From: Strauch, Bradley <bradley.strauch@pse.com>
Sent: Tuesday, January 22, 2019 9:30 AM
To: Bedwell, Heidi
Subject: Response to comments
Attachments: PSE EE Response to Public Comment Jan 2019 Update.pdf

PSE Energize Eastside - Response to Public Comment
Updated - January 2019

Site Plan - Hillshade	
PSE Energize Eastside Comment Response Bellevue, Washington	
	Figure 3

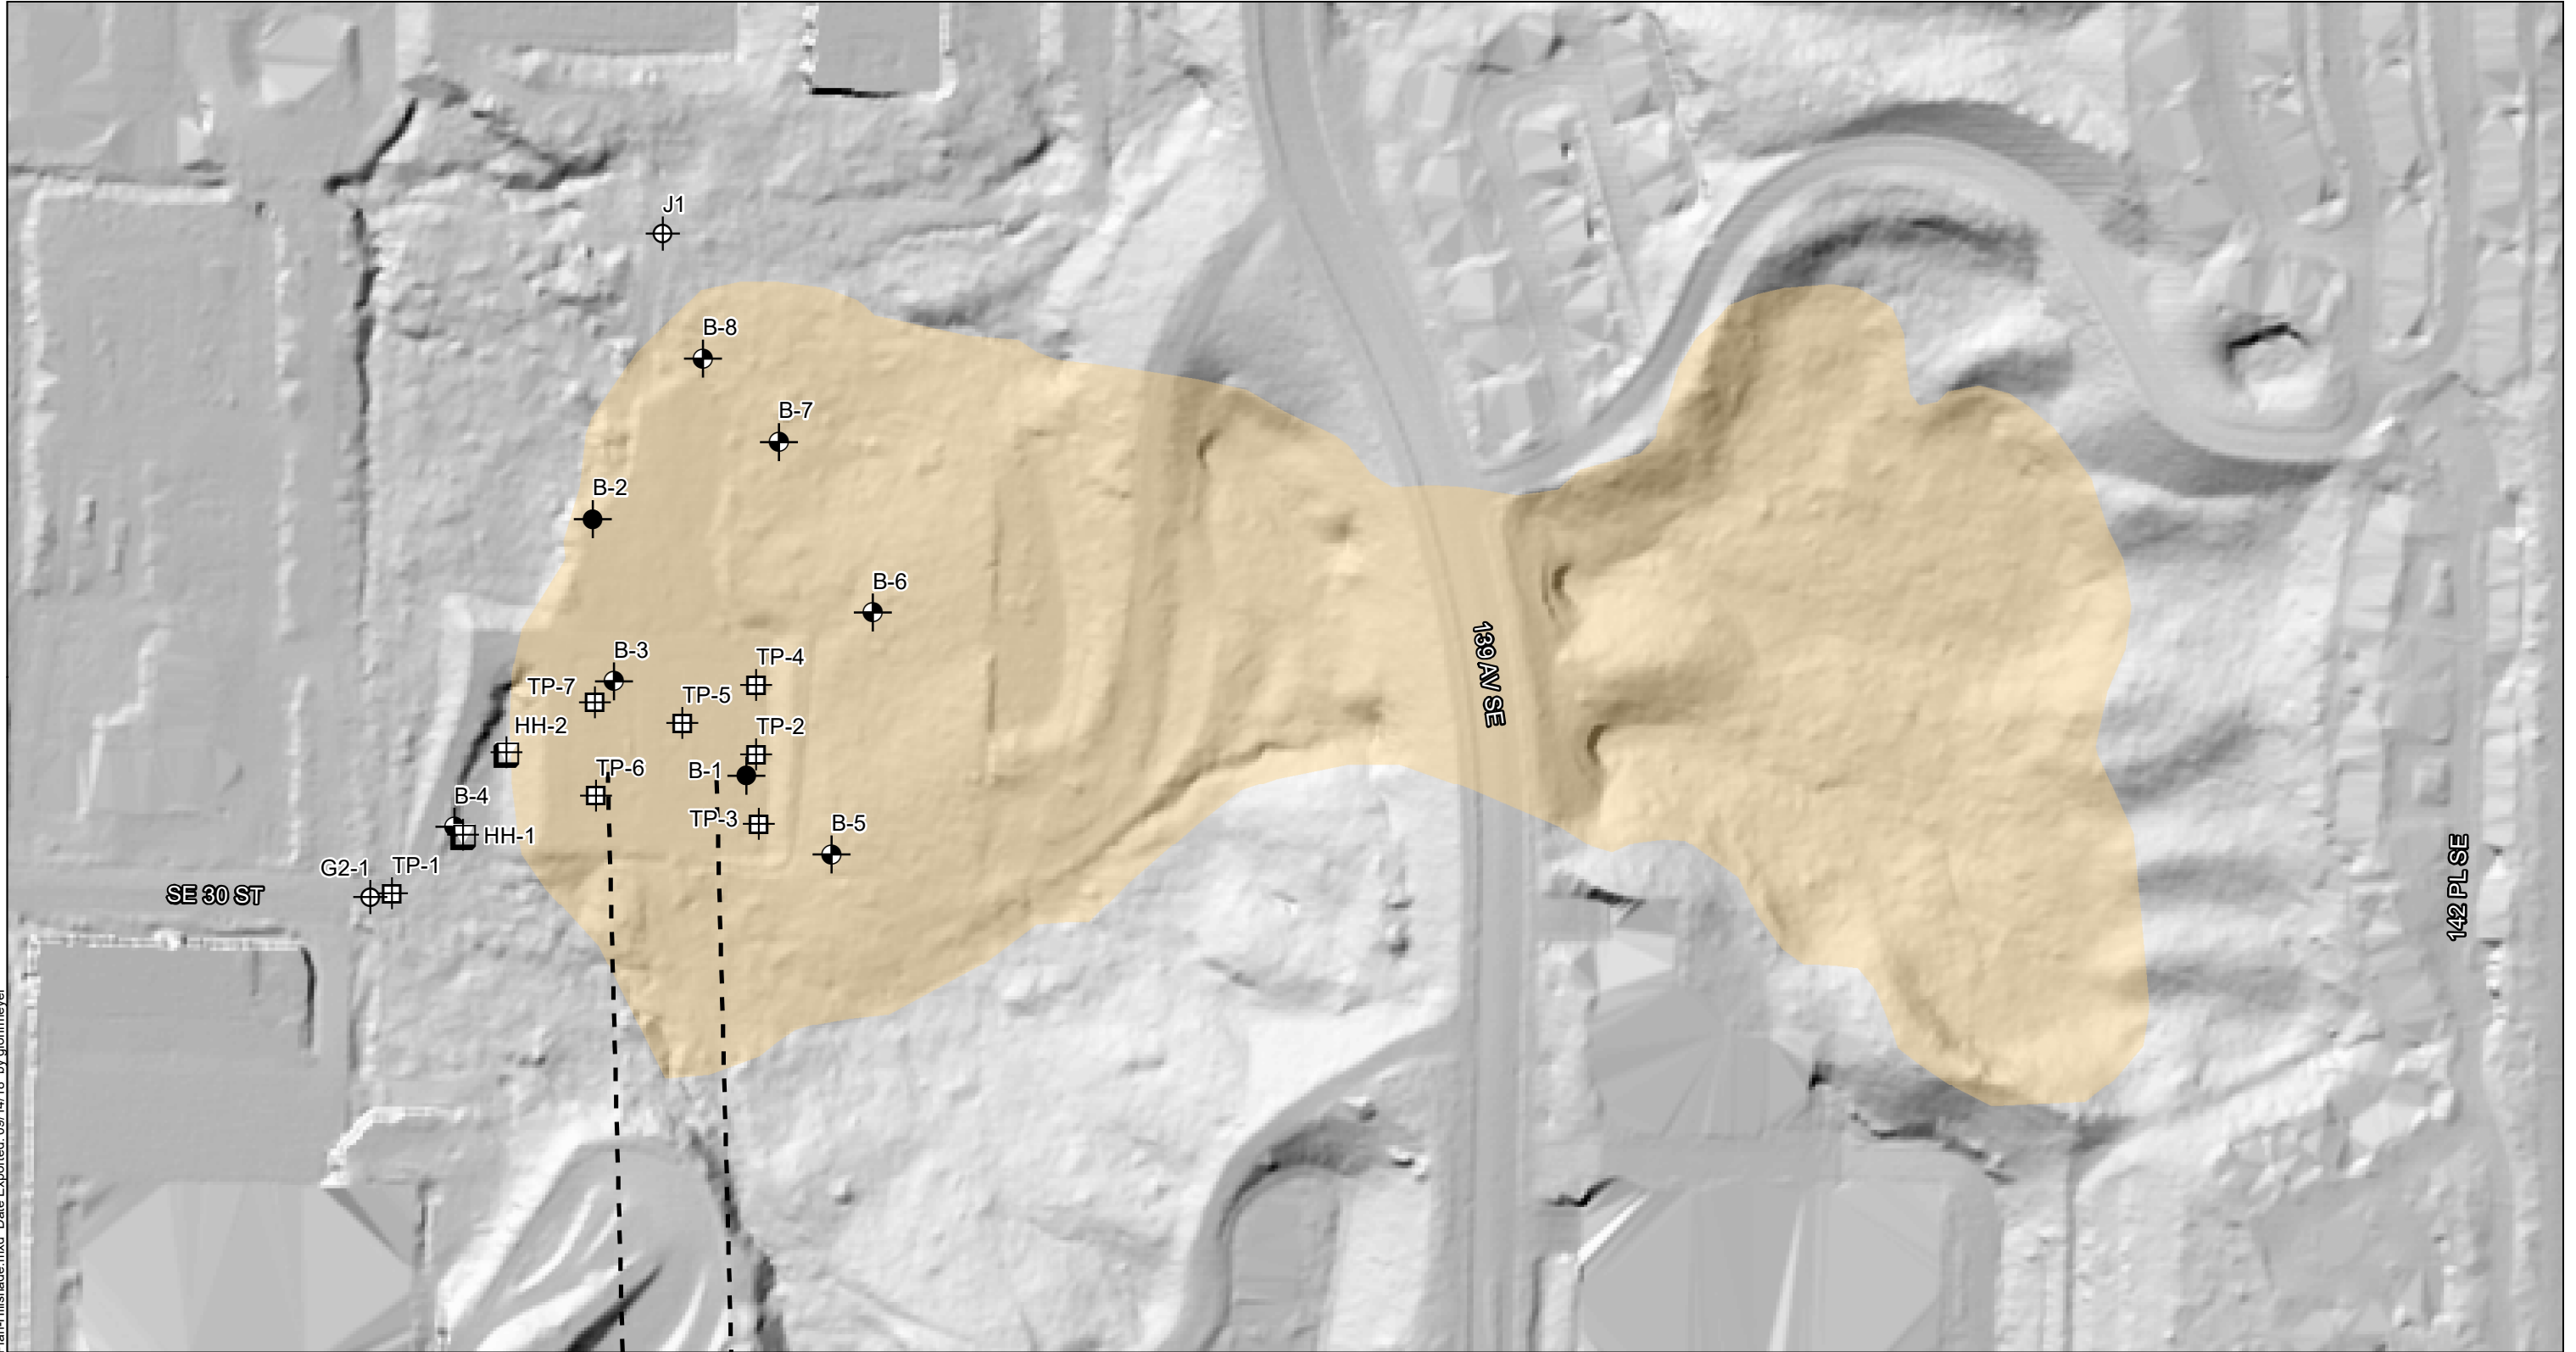
GeoEngineers, Inc. (GeoEngineers) has prepared this memorandum in response to a City of Bellevue (City) land use review comment related to the Critical Areas Report for the Richards Creeks Substation, dated July 11, 2017. The general location of the Richards Creek Substation is presented in Figure 1, Vicinity Map. Kelly Purnell of Puget Sound Energy (PSE) requested this memorandum during a phone conversation with Chip Barnett on August 16, 2018. This memorandum incorporates comments from Kerry Kriner of PSE received on September 6, 2018. The City provided the following land use review comment in a letter dated August 14, 2018:

(Figure 3) and during our site reconnaissance. Furthermore, it is our opinion that the area mapped as a landslide does not include geomorphic characteristics consistent with a landslide. Based on our review of the LiDAR data (Figure 3), the mapped area does not appear to be a landslide but rather cut and fill slopes associated with site development and roadways, including 139 Avenue SE that is east of the proposed PSE substation.
